# CITY OF ALBUQUERQUE

**Re: Starbuck Drive-Thru**  
**1314 Gibson Blvd. SE Albuquerque NM 87106**  
**Traffic Circulation Layout**  
Engineer's/Architect's Stamp 01-16-20 (L15D041)

**SITE TRAFFIC CONTROL & LAYOUT PLAN**

WMM via: email  
C: CO Clerk, File

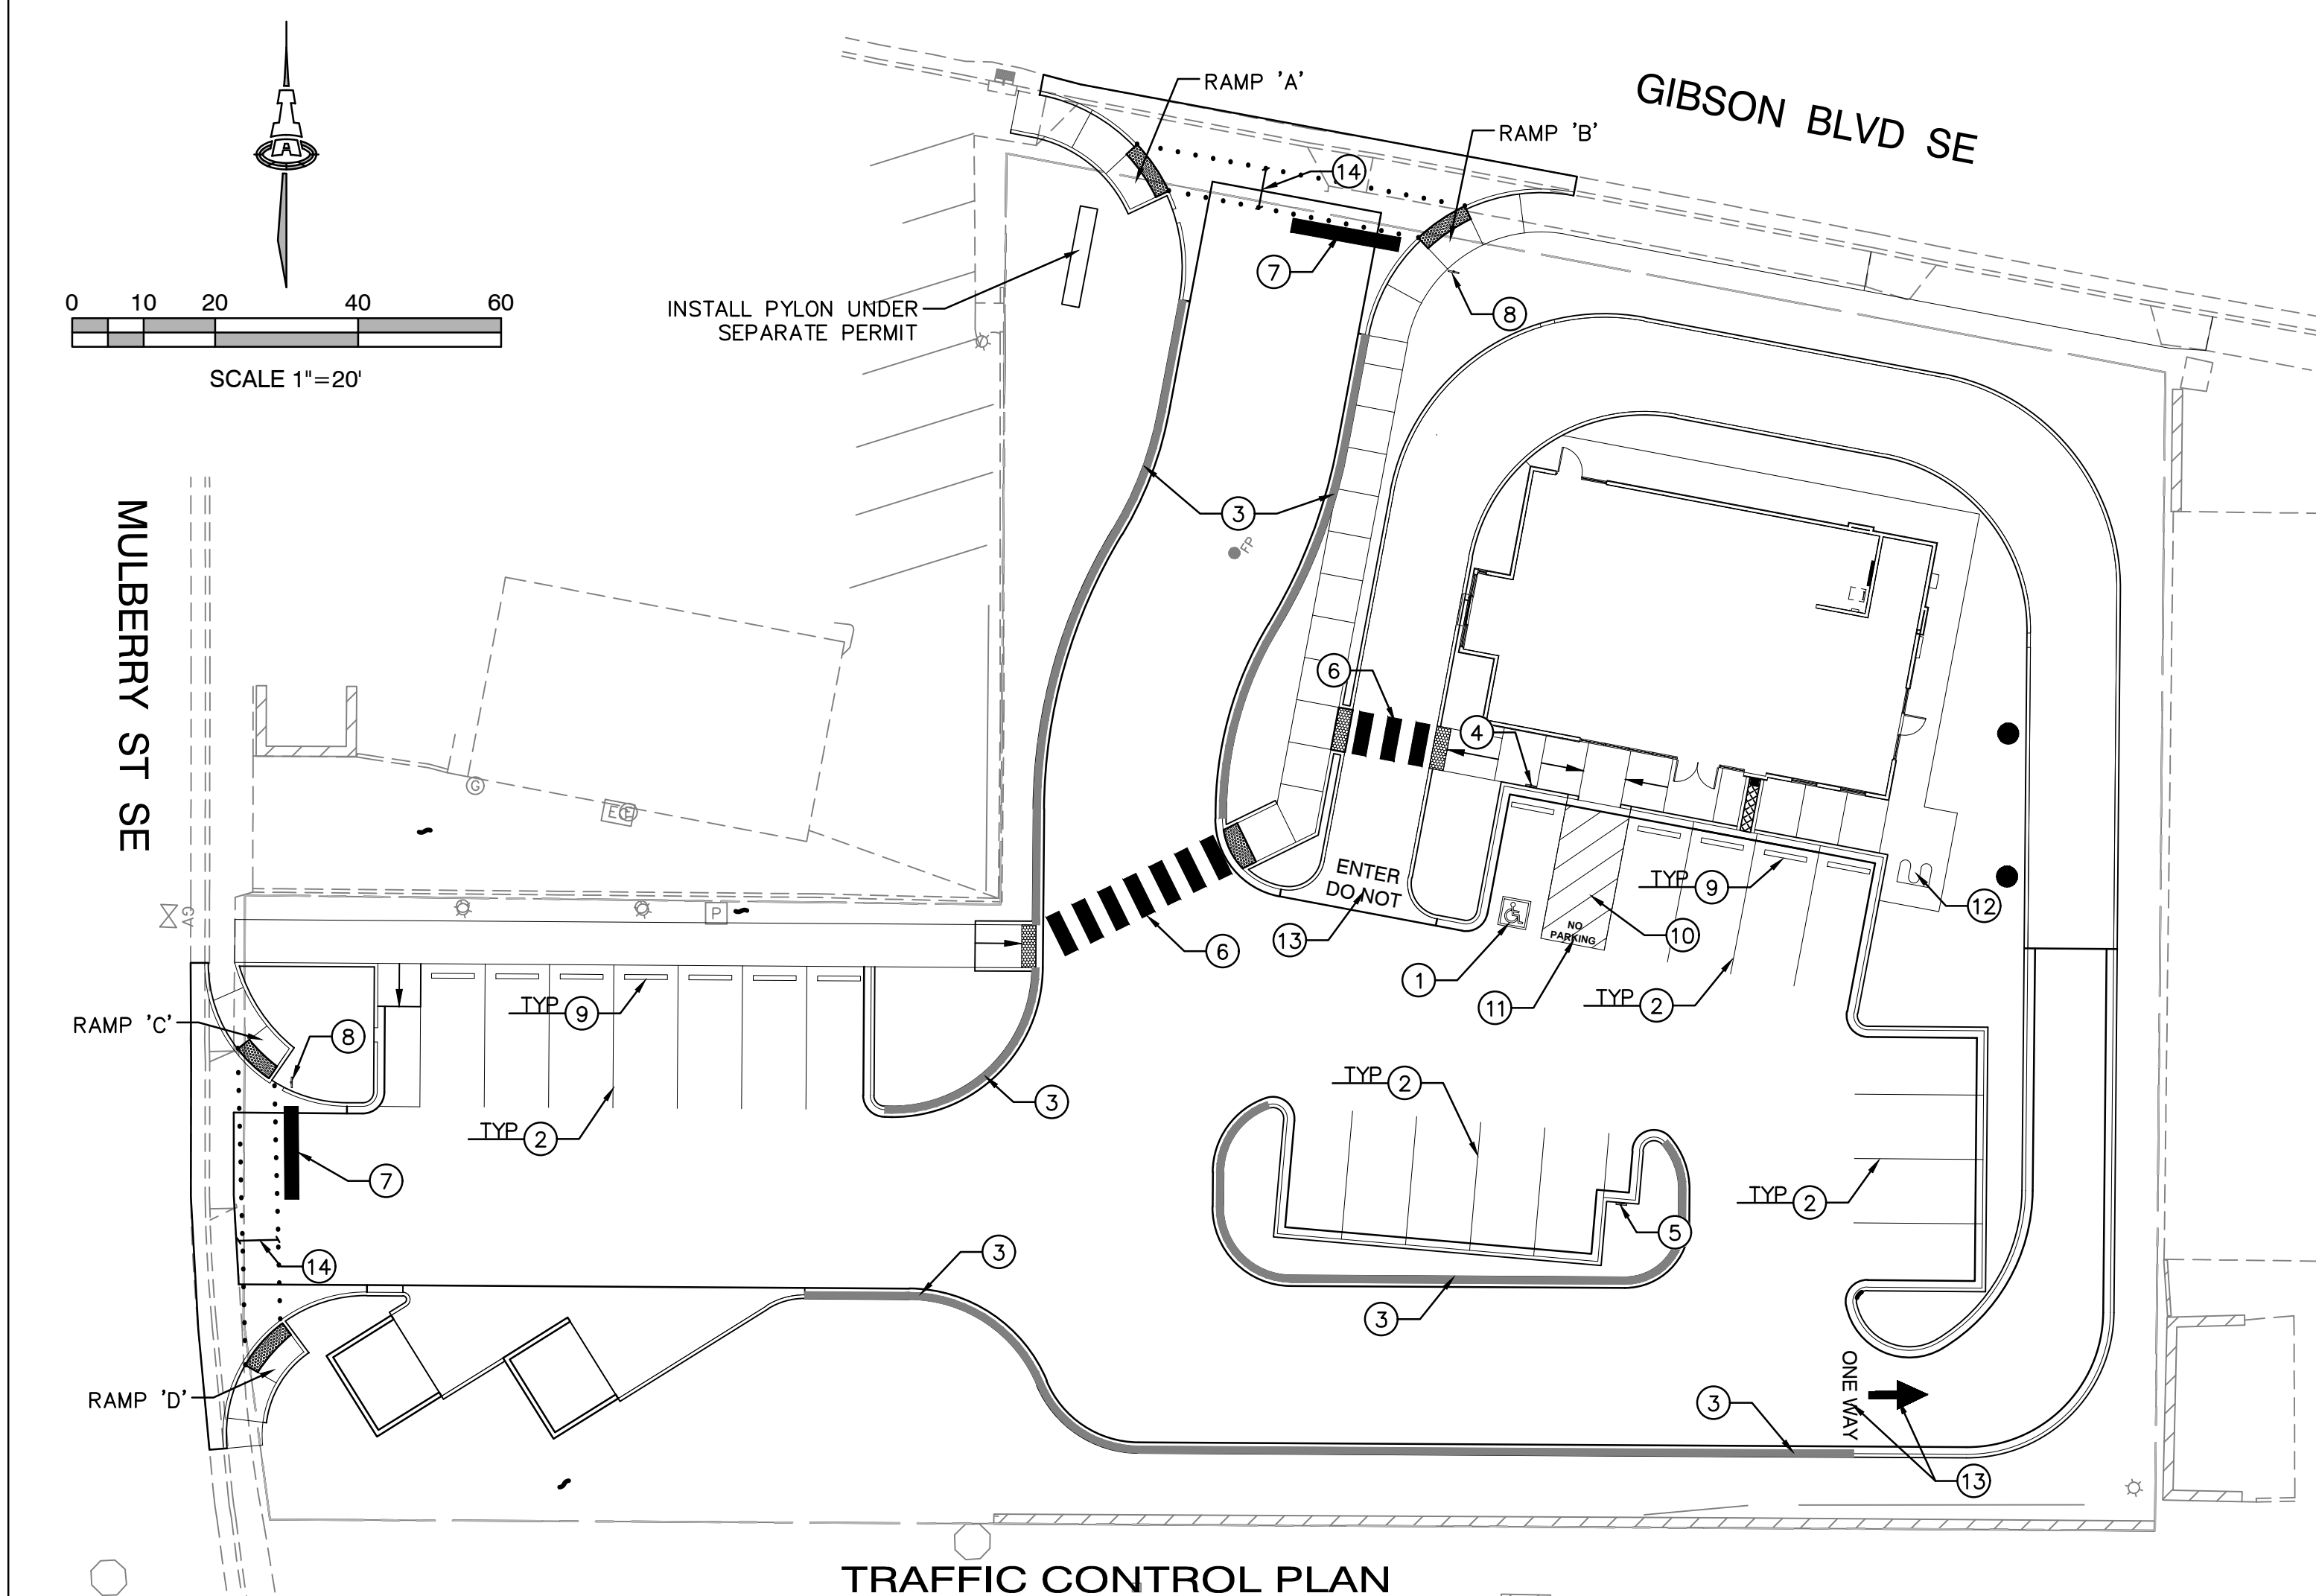
1. Please show a vicinity map showing the location of the development in relation to streets and well known landmarks.
2. List the number of parking spaces required by the zoning code as well as the proposed number of parking spaces including bicycle and motorcycle parking.

3. The ADA accessible parking sign must have the required language per 66-7-352.4C NMSA 1978 **"Violators Are Subject to a Fine and/or Towing."** **Please call out detail and location of signs.**

4. Please show the bike rack detail.
5. Refuse vehicle maneuvering shall be contained on-site. The refuse vehicle shall not back into the public right of way.; **provide a copy of refuse approval.**

6. It is not apparent what type of pavement surface is being proposed. A hard driving surface will be required as part of this proposed project for parking area and drive aisles.

7. All one-way drives shall have **"One Way"** and **"Do Not Enter"** signage and pavement markings. Please show detail and location of posted signs and striping.

8. Show the clear sight triangle and add the following note to the plan:  
"Landscaping and signage will not interfere with clear sight requirements. Therefore, signs, walls, trees, and shrubbery between 3 and 8 feet tall (as measured from the gutter pan) will not be acceptable in the clear sight triangle.

9. Unused curb cuts must be replaced with sidewalk and curb & gutter. A build note must be provided referring to the appropriate City Standard drawing.

10. Add a note stating "All broken or cracked sidewalk must be replaced with sidewalk and curb & gutter." A build note must be provided referring to the appropriate City Standard drawing.
